**RNAV 1 (GNSS)
STANDARD DEPARTURE CHART
INSTRUMENT (SID) - ICAO**

**Kraków - Balice
RWY 07**

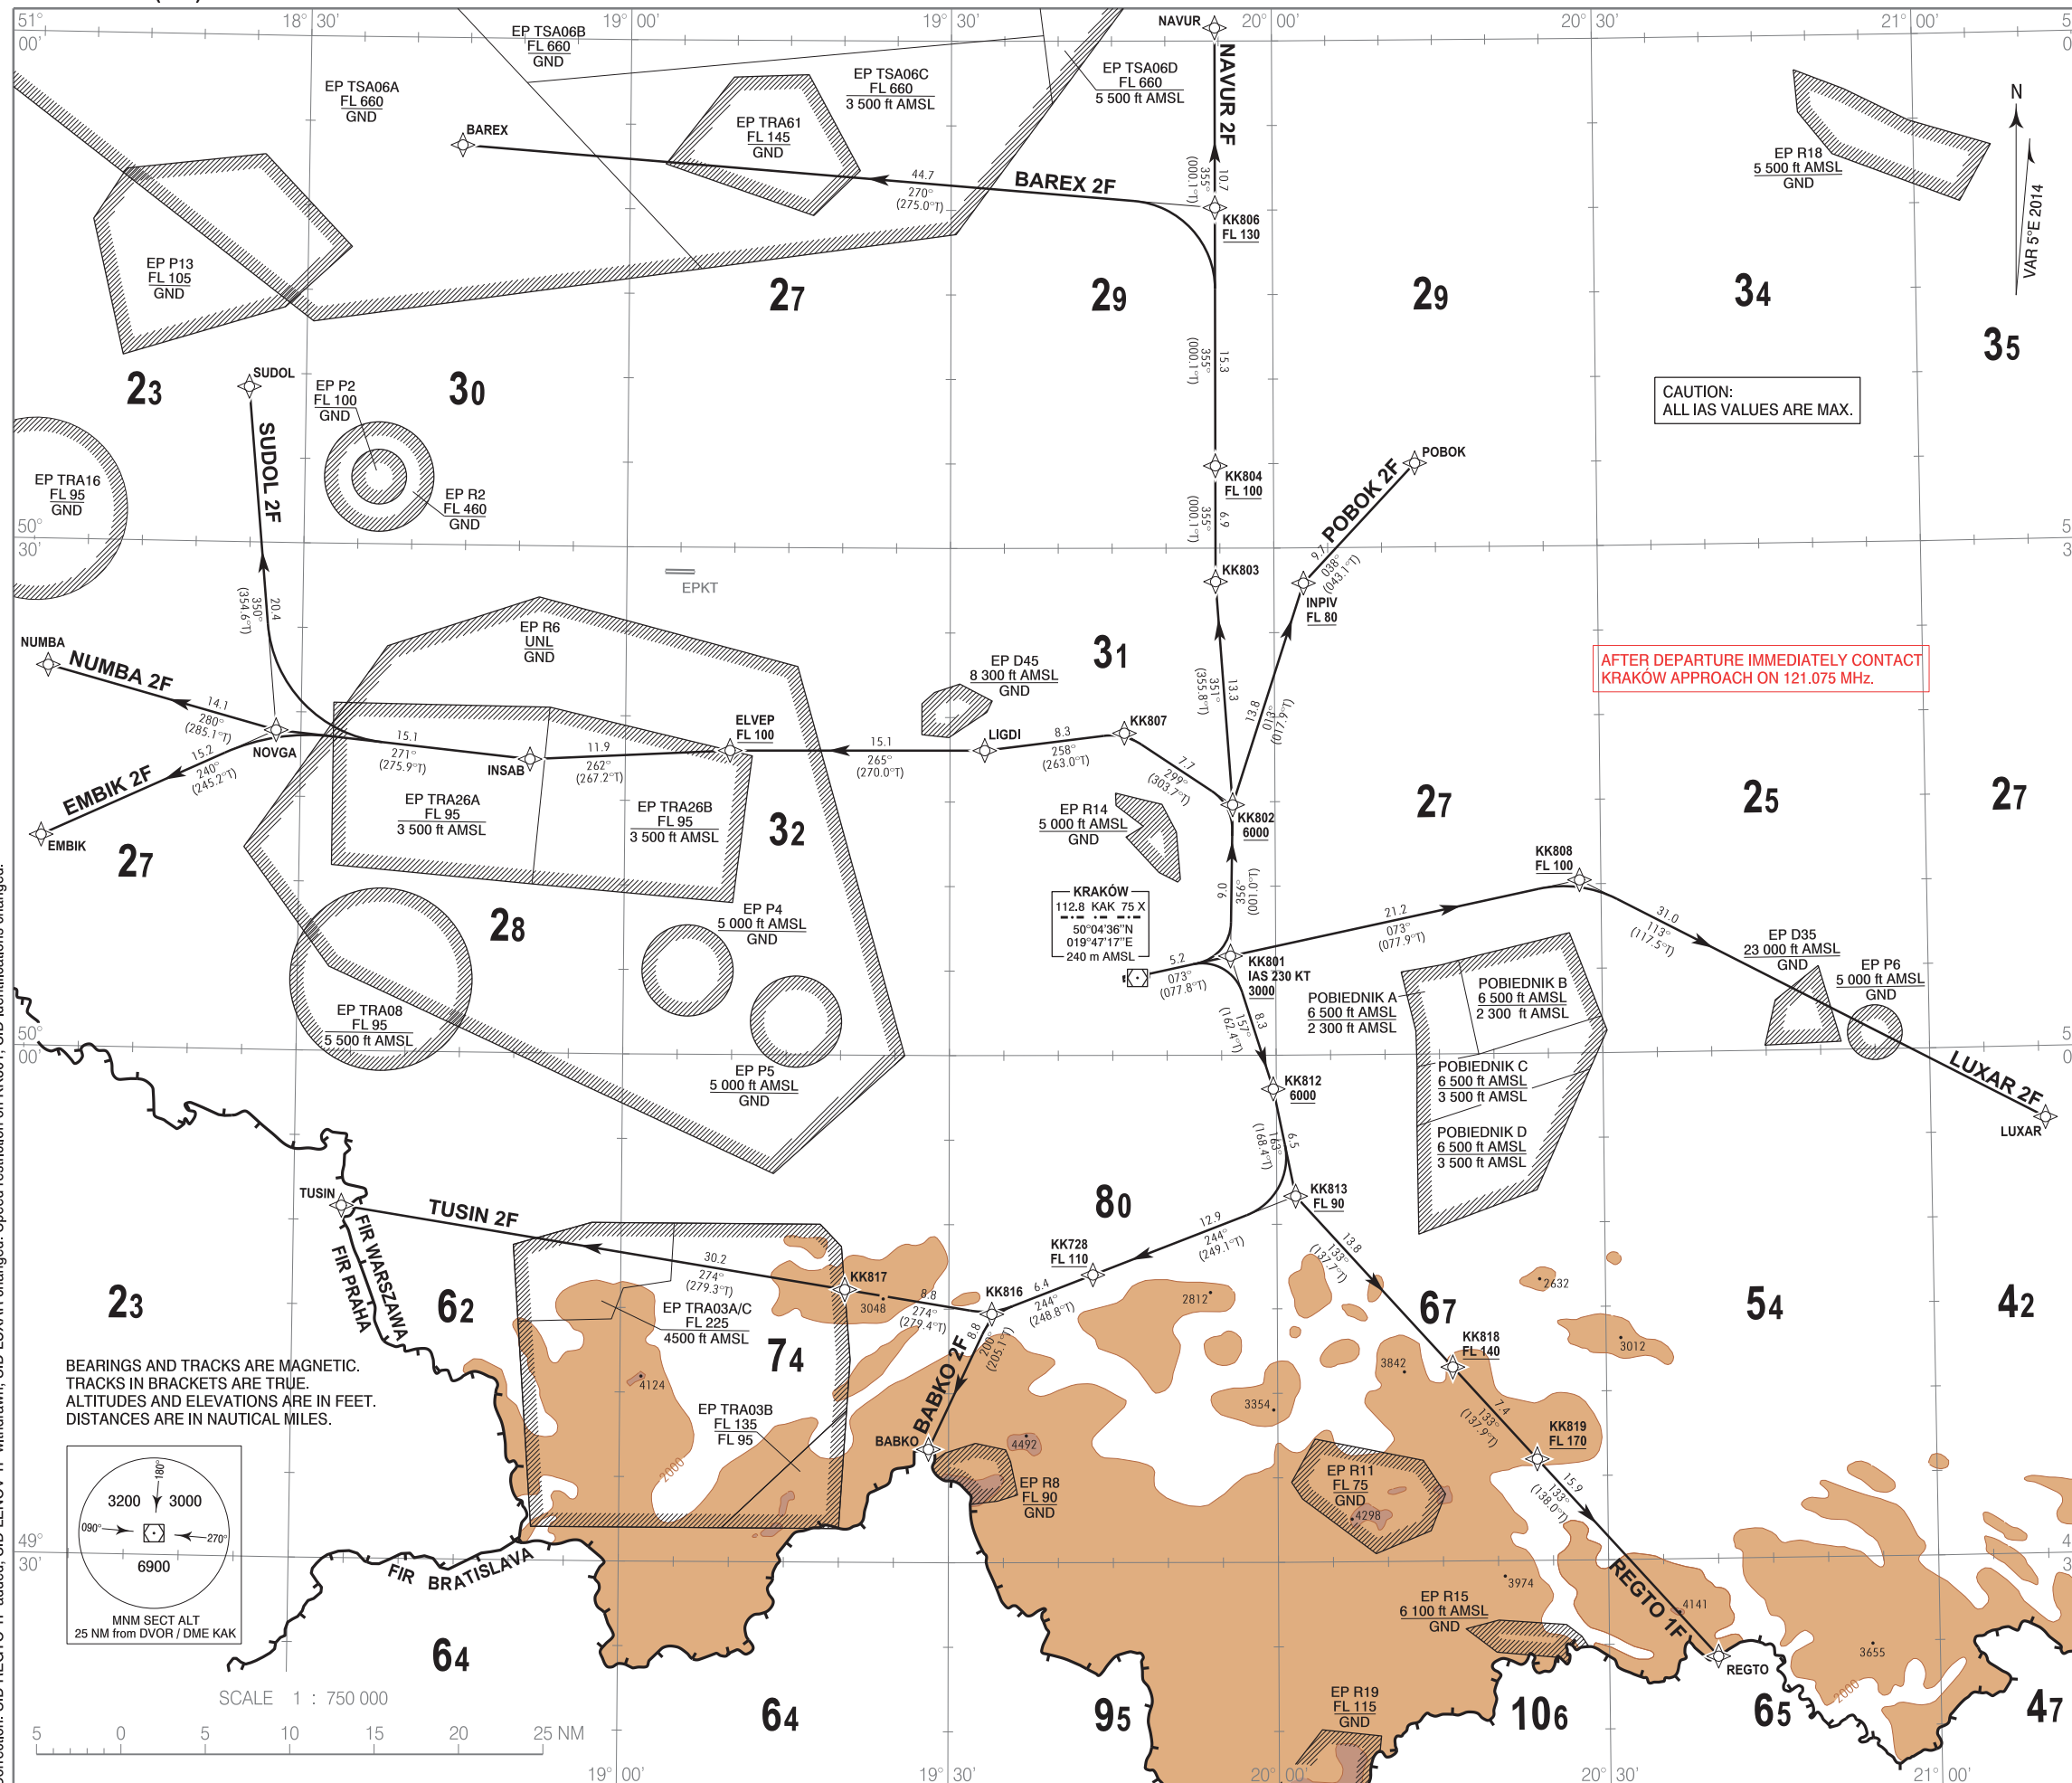
Correction: SID REGTO 1F added, SID LENOV 1F withdrawn, SID LUXAR changed. Speed restriction on KK801, SID identifications changed.
